**Field-Truthing and Monitoring of the Proposed PennEast Pipeline,
FERC Draft EIS, Docket No. CP15-558**

September, 2016

Prepared by: Delaware Riverkeeper Network

Figure 1. Penn East Alignment Drawing 000-03-01-212 Revision D. Illustrating an HDD entry work space within a wetland

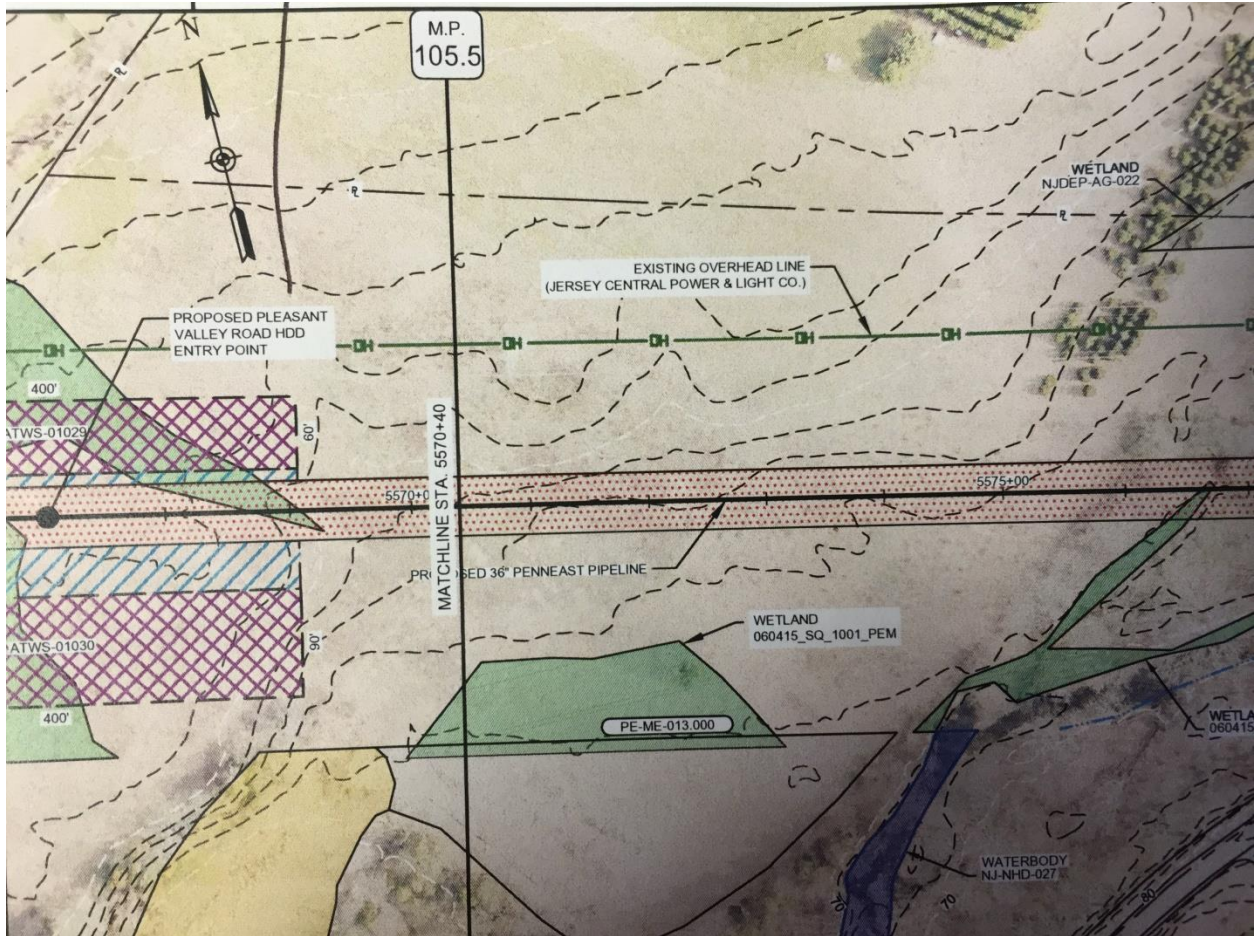
HDD long borings should be considered and analyzed for feasibility for each and every waterbody crossing along the route to reduce impacts to sensitive habitats.^{vi} However, in some instances, HDD entrance and exit points which often require large land clearings and impacts to soils are proposed by PE to be located in sensitive wetland and forested habitats. This practice is another indication that avoidance and minimization is not fully being considered for wetlands and waterbodies and the most technological advanced measures and proper citing of HDD are not being considered. For example, in Mercer Co. New Jersey, a horizontal directional drill (HDD) is proposed under Pleasant Valley Rd. and an adjacent stream and wetland complex (between MP 105.5 and 106.0) (see figure 1). However, in this instance, the HDD entry point is proposed to be located at MP 105.4 and within a large PEM wetland complex (1002-PEM and 1001-PEM). According to alignment sheets, that HDD entry point in the wetland would require temporary work space on either side of the permanent ROW in addition to a 400' by 90' and 400' by 60' ATWS on either side of the permanent ROW within the wetland. It would be less impactful to extend the HDD entry point westward away from the waterbody or forest to reduce impacts and to encourage longer HDD borings to better avoid impacts from open cuts.

Figure 2. Penn East Alignment Drawing 000-03-01-213 Revision D. Illustrating an HDD exit work space adjacent a wetland and parallel a stream. Mature trees also appear to possibly located in this reach though faded alignments are provided by PE which make land use determination difficult.

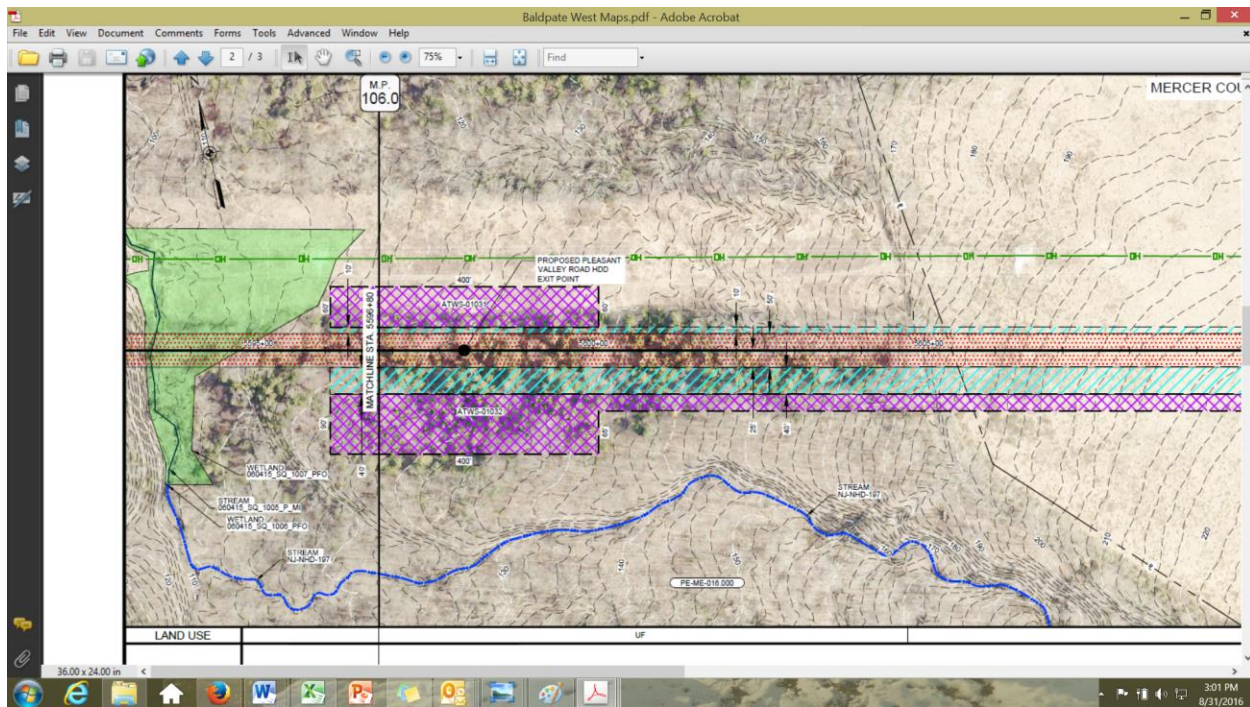
The exit point for this same proposed HDD section is proposed just adjacent another wetland complex and just north of and paralleling a stream (see figure 2). The faded aerial overlays that are provided by Penn East in alignment sheets are unclear but it appears mature trees may be cut for this HDD exit point. Again, it would be less impactful to extend the HDD to a location where already impacted land would not be harmed since technology is feasible to drill for longer segments, thereby reducing impacts. An HDD should be required in this MP area to minimize harm to the point pleasant wetland and stream complex but the citing for the exit and entrance points is inappropriate yet it has been deemed acceptable impact by FERC.

Figure 3: Vernal pools and groundwater seeps along base of Blue Mountain. Note red line depicts pipeline route with 400 ft. survey area. Herpetologists recommend 1,000 ft buffer of upland to protect vernal pool species.

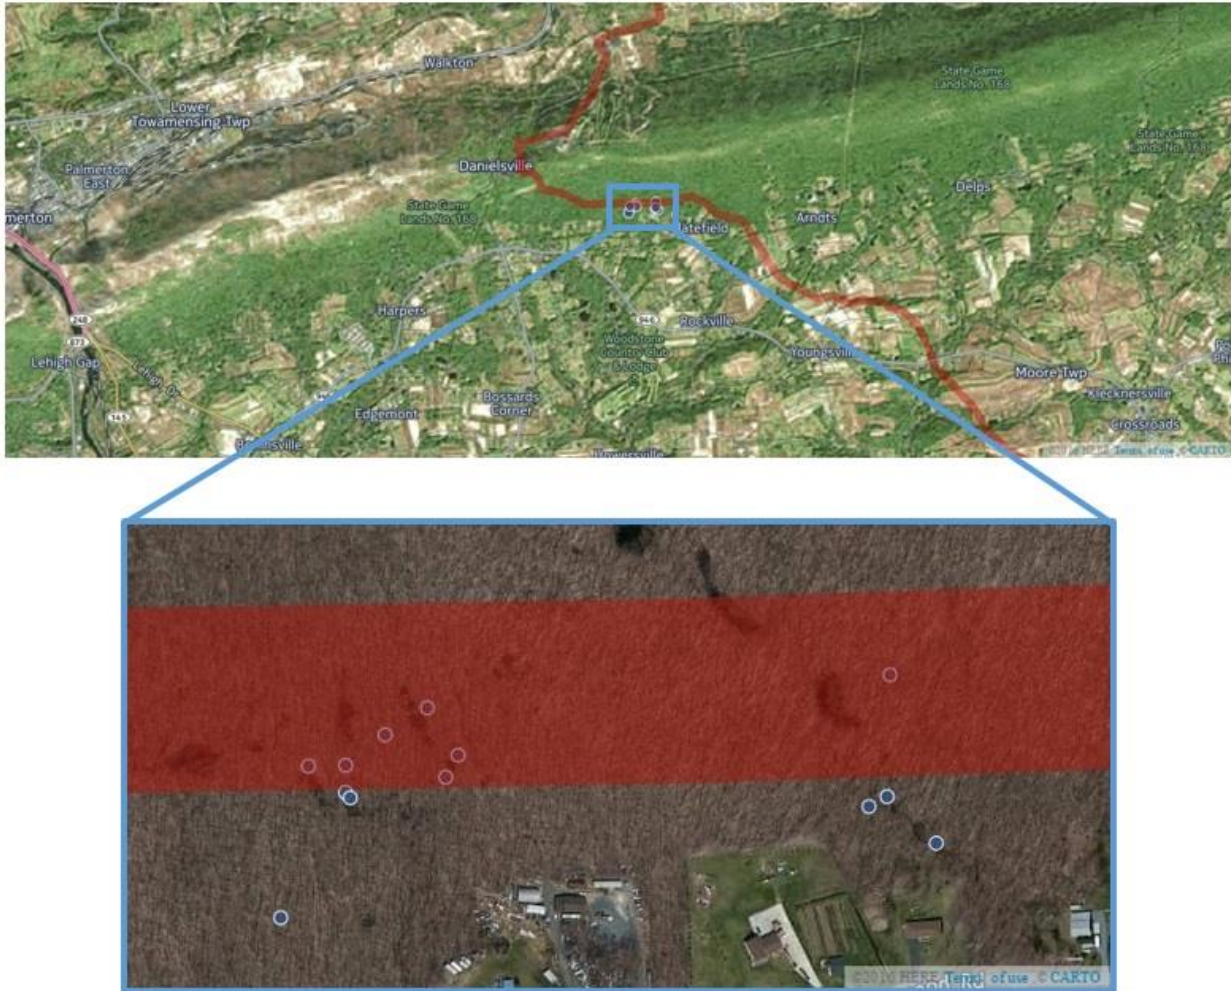
For example, DRN field-truthed and surveyed SGL 168 along MP 52.4 to MP 52.9 on August 28, 2016 after reviewing PE wetland delineation maps (maps not part of the DEIS) and alignment

sheets (Revision D) that showed there were only three vernal pool habitats present in this area of the route. (072415_JC_1001_VP, 072415_JC_1003_VP, 72415_JC_1002_VP on Figure 3 Sheets 129 and 130, PE wetland delineation map). When DRN assessed and walked this section of pipeline, it was clear vernal pool habitats were missed even in areas that PE has noted as being surveyed. DRN documented 12 vernal pools or potential vernal pool complexes and groundwater seeps and depressions that may serve as habitat along this same area of the pipeline route (see Figure 3). Table G-11 of the DEIS notes only two vernal pools in this area at MP 52.4 and MP 52.6 and both are forested yet an open cut (25 feet and 67 feet) is the crossing type PE is proposing. One stream, an UNT to Indian Creek at 52.4 is documented by PE on Table G-7. No groundwater seeps or springs have been documented by PE in this area. This is not protective of the vernal forested pool habitats that obligate and facultative vernal pool species require and it also does not include or map all vernal pools and groundwater seeps that were present in this reach of the proposed route. Table G-11 in the FERC EIS and the wetland delineation maps provided by PE are also not consistent.

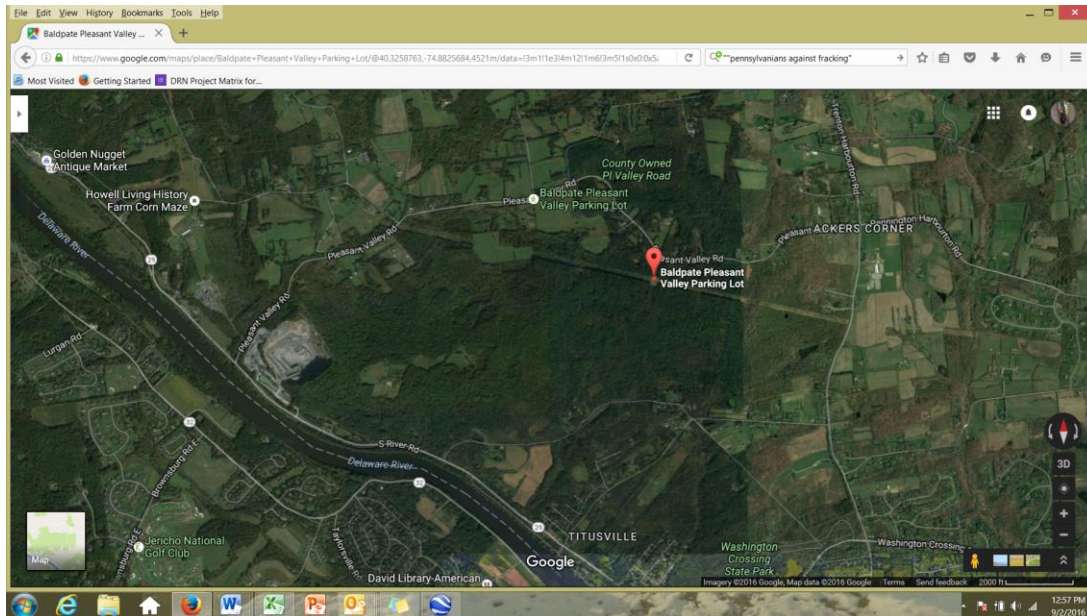
On July 30, 2016, DRN field-truthed a short section of the proposed PE pipeline corridor along Ted Stiles Preserve at Baldpate Mountain in Hopewell Township, New Jersey (MP 107.2 to MP 106.8). DRN walked west from the Baldpate parking area about a half mile just south of the existing electrical ROW.

Figure 12: DRN walked west from the Access Pleasant valley road parking area on July 30, 2016 and documented within 0.5 miles one obvious intermittent stream missing from PE wetland and alignment sheet maps. Shagbark hickories and other important mature trees that provide refuge for bat species were documented. Invasive plants were documented along existing JCP&L ROW that would be exacerbated and spread with a new ROW.

Figure 13. Approx. location of the intermittent stream within proposed ROW corridor on Ted Stiles Preserve at Baldpate Mountain not mapped by Penn East

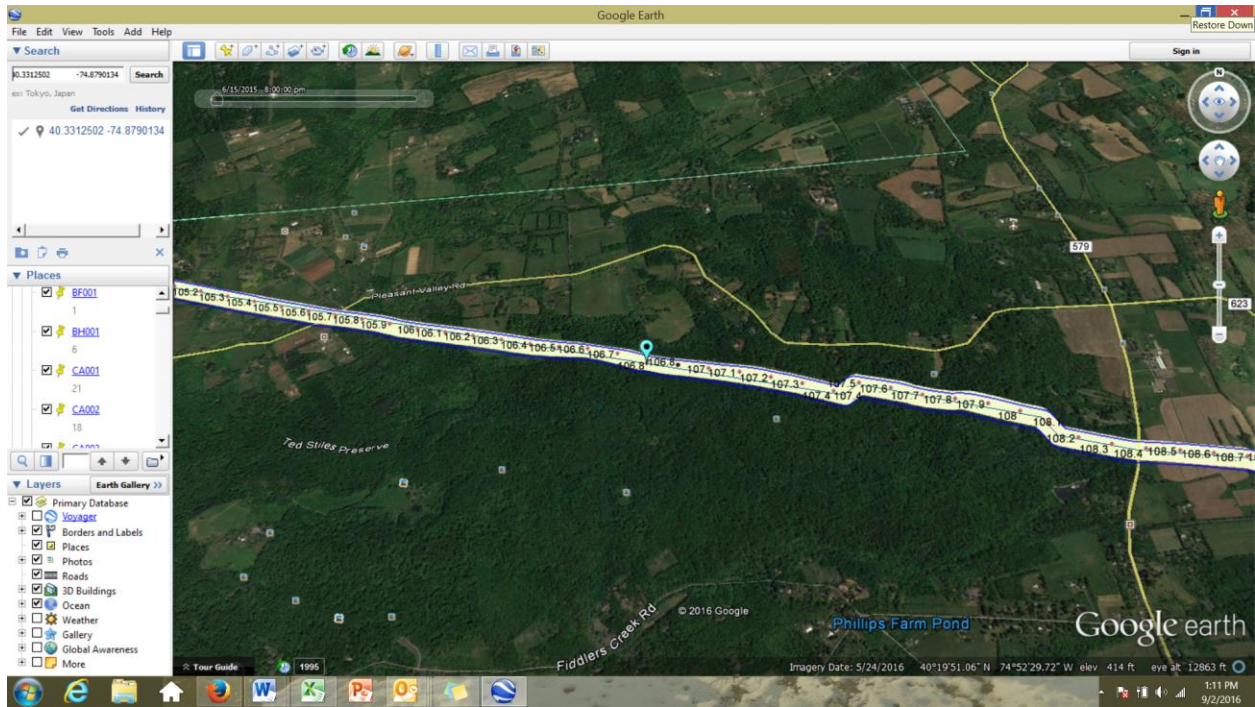
This Mercer County Public Park has over 12 miles of marked trails for hiking, horseback riding, mountain biking, and trail running. According to the DEIS and PE alignment sheets, this area had been surveyed by PE. No flagging was observed during ground-truthing for the pipeline center line, or any of the wetlands or streams along the proposed pipeline route we encountered as late as July 30, 2016. An intermittent stream was not delineated on the PE alignment sheets nor was there flagging present to note this water feature despite the fact that the stream is delineated on state freshwater mapping layers available to the public. Table G-6 in the DEIS also does not list this stream as a waterbody to be cut.

Figure 16: Stream temperatures for UNT to Wickecheoke Creek (Plum Creek) (MP 95.1)

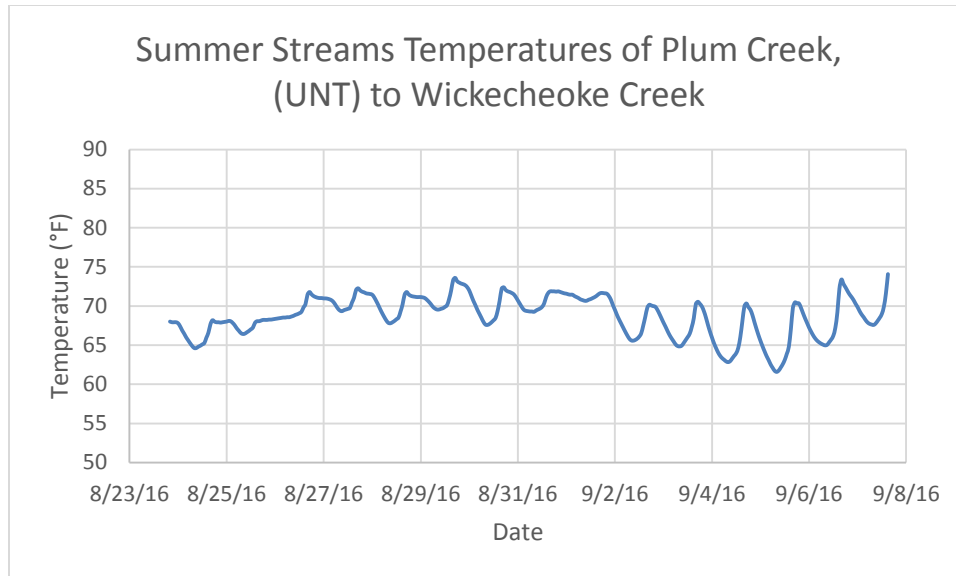
The temperatures observed in Plum Creek, an UNT to Wickecheoke Creek, a C1 stream (FW2-NTC1) in New Jersey (located at MP 95.1) indicates conditions that groundwater seepage is assisting to help sustain and cool this important C1 tributary. This area of the stream is in the very headwaters and upstream of a large pond that eventually continues downstream to feed the Wickecheoke Creek. The temperatures range from 61.6°F to 74.0°F, with a mean of 68.7°F. The conductivity of Plum Creek on 9/7/2016 was 270 uS/cm and on In addition this stream, is currently private and preserved farmland and native plant meadows with a healthy forested riparian buffer along the stream. The PE is proposing to cut down mature trees and cut across this stream using a dry crossing and the construction period is estimated to be July 16 – September 30. However, if the proposed pipeline ROW crosses the stream at this location, it would impact and likely alter groundwater flows. Furthermore, Table G-6 in the DEIS lists 10 pipeline cuts across the Wickecheoke watershed proposed just for the Penn East pipeline alone. Most cuts are proposed to be dry crossings conducted 7/1 to 9/30 or 6/16 to 9/30 with the exception of one bore at MP 96.8. Table G-8 at MP 95.3 lists a waterbody as UNK. Despite multiple cuts across these watersheds, FERC fails to require any other measures to ensure cumulative impacts for these cuts is adequately monitored or considered on a sub-watershed or a larger watershed context.

Figure 18: Wetland delineation maps not part of DEIS package

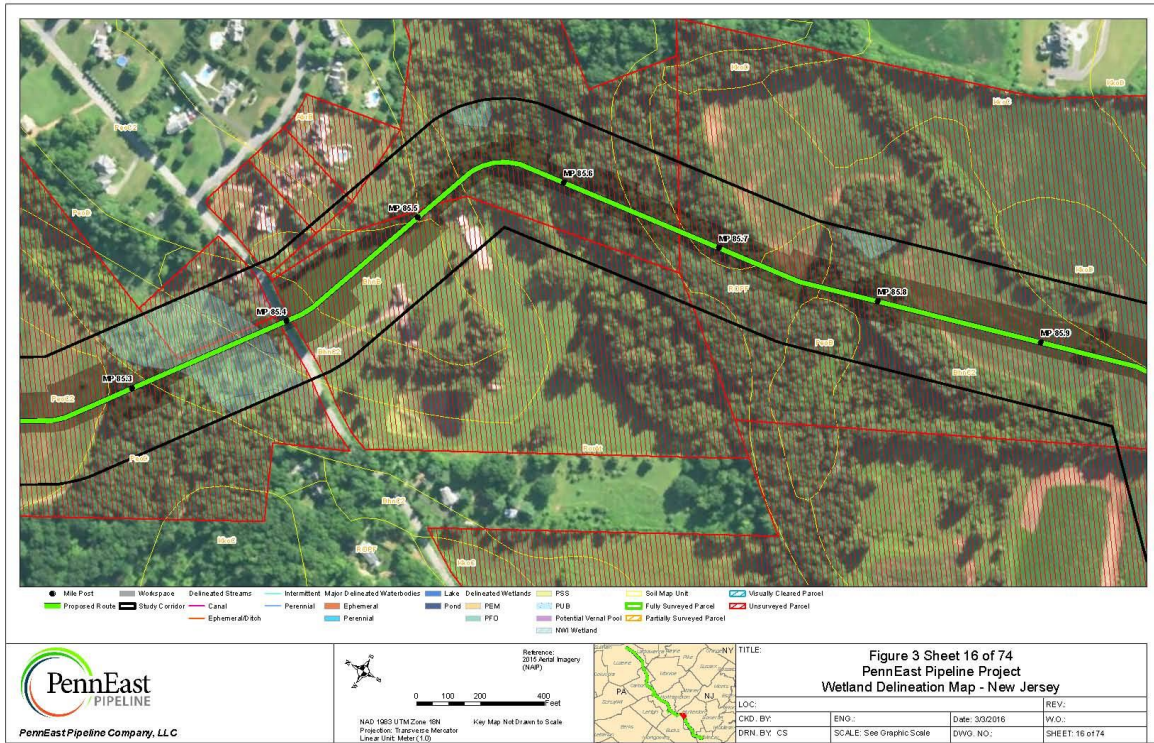
The crossing lengths identified by PE appear inaccurate and photos below indicate more disturbance of PFO depending on the alignment. The DEIS lists for this wetland complex the PFO is only 1 ft., the PSS 227 ft., and the PEM 79 ft. With some mature trees being present in the wetland, a 1 foot PFO estimate does not adequately account for the large trees likely to be cut. But no alignment sheets are updated for this deviation of the pipeline route in the DEIS plus alignment sheets included do not have MPs delineated like earlier versions which makes it difficult to cross reference waterbody crossings with MPs in the field esp. since so much of the areas have not been flagged by PE in the field. Without updated alignments sheets which FERC states only need be provided before construction, field visits and independent reviews cannot easily be provided by the public for a thorough review of ATWS or TWS which may be included at this crossing. Landowners on deviations also do not appear to have access to the alignment sheets at this time either. This inadequacy of mapping in the draft EIS is a gross omission by FERC. The map below is from the wetland delineation report for this wetland and stream (MP 85.3 to MP 85.4) which does not provide detailed construction plans as the alignments do (these maps were obtained from the DRBC website not the DEIS). Note the unsurveyed field parcels here by PE (red hatch). These delineation maps were not part of the DEIS volumes provided by FERC which indicates another missing piece and data source that is not readily accessible nor made available at all to the public and community reviewing the DEIS.

Figure 21: Temperature Data from UNT to Harihokake Creek that flows through wetland complex

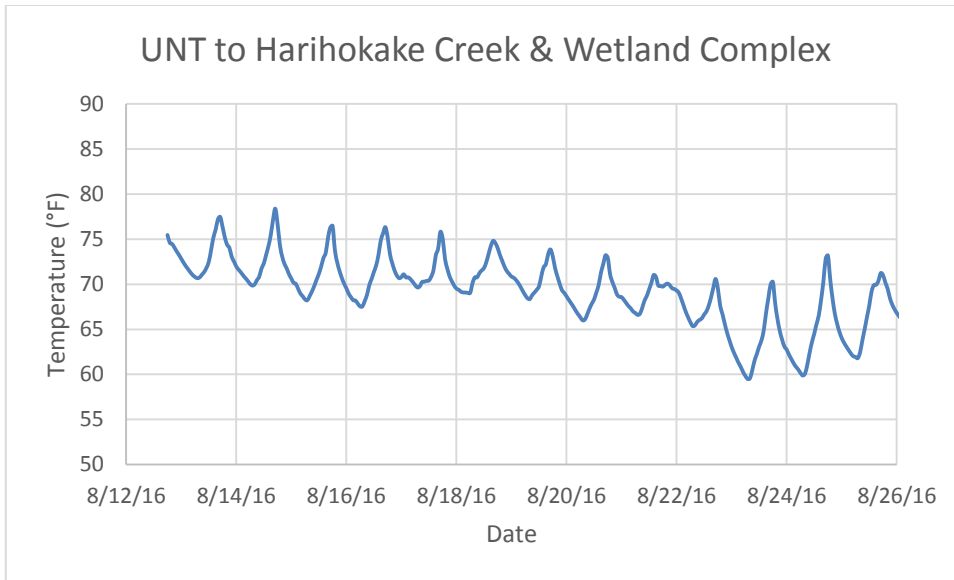
The summer stream temperatures collected from this station on the UNT and wetland are indicative of good water quality, ranging from 59.5°F to 79.0°F, with a mean of 69.4°F. The conductivity of the stream on 8/12/16 was 371 uS/cm. From Aug 27 to Sept 7, 2016 the stream was dry and the HOBO probe was taking air temps as a result (air temps. removed from graph above). These dry conditions indicate the very sensitive nature of these headwater streams and wetland complexes PE proposes to cross. The proposed ROW would cut across this wetland and stream complex bringing with it cascading and long term impacts that would impact stream and wetland temperatures and reduce shading and habitat that is currently present in this wetland complex. The proposed ROW would cross the Harihokake and its tributaries at 7 different locations (MP 85.4, 85.6, 85.8, 85.9, 86, 86.3, 86.7), which poses a threat to this watershed individually and cumulatively. Again, FERC has not assessed the cumulative impact of all of these cuts across watersheds, FERC has not required in situ information or stream water quality conditions to be collected by PE, FERC has not required updated alignment sheets and maps – all gross errors and omissions in the DEIS.

Figure 23: Temperature data for Alexauken Creek, by ROW

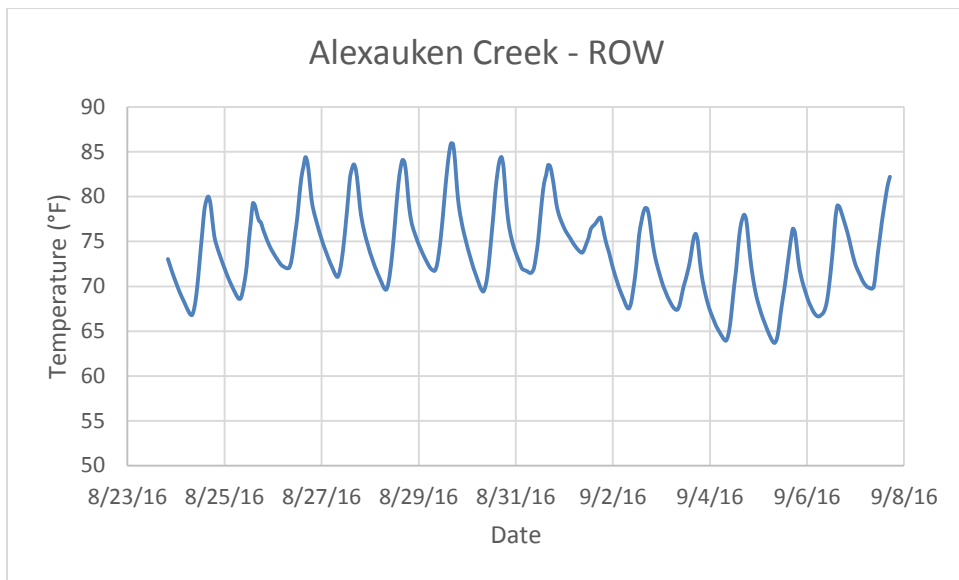
The data from the ROW logging station on the Alexauken show daily fluctuation. The temperatures range from 63.7 °F to 85.9 °F, with a mean of 73.7 °F. Whereas, the data collected from the other non-ROW station show much less fluctuations in temperature. For this station, the temperatures ranged from 66.4 °F to 78.5 °F, with a mean of 72.7 °F. Aquatic species generally have a preferred temperature range, and thrive in more stable temperature conditions. A ROW close to a waterbody means that air temperature would affect water temperature more rapidly. These rapidly fluctuating temperatures can wreak havoc on aquatic life. In comparison, a water body away from ROW and surrounded by forested land, would not be affected by air temperature as much, since the forest would act as a buffer to regulate water temperature. These trends can be clearly seen in the data collected for Alexauken Creek. The station by the ROW not only had a higher mean temperature, a much higher maximum temperature than the other station.

Alexauken Creek is classified as a trout maintenance stream (FW2-TMC1). According to N.J.A.C. 7:9B-1.14(d), the temperature for this stream shall not exceed 25°C (77°C). The temperatures from Alexauken Creek certainly exceeded this standard, which shows that the stream is already impacted (it is an impaired waterbody). With the proposed pipeline ROW, right along these stations (as seen in Figure 1), the degree of impact will be greater, which can prove fatal to the local ecosystem. The proposed PE pipeline would cross the Alexauken and its tributaries 7 times, which poses a threat to the already impacted stream. In a December 2010 report, by Princeton Hydro (in collaboration with the Delaware Riverkeeper Network), Alexauken Creek
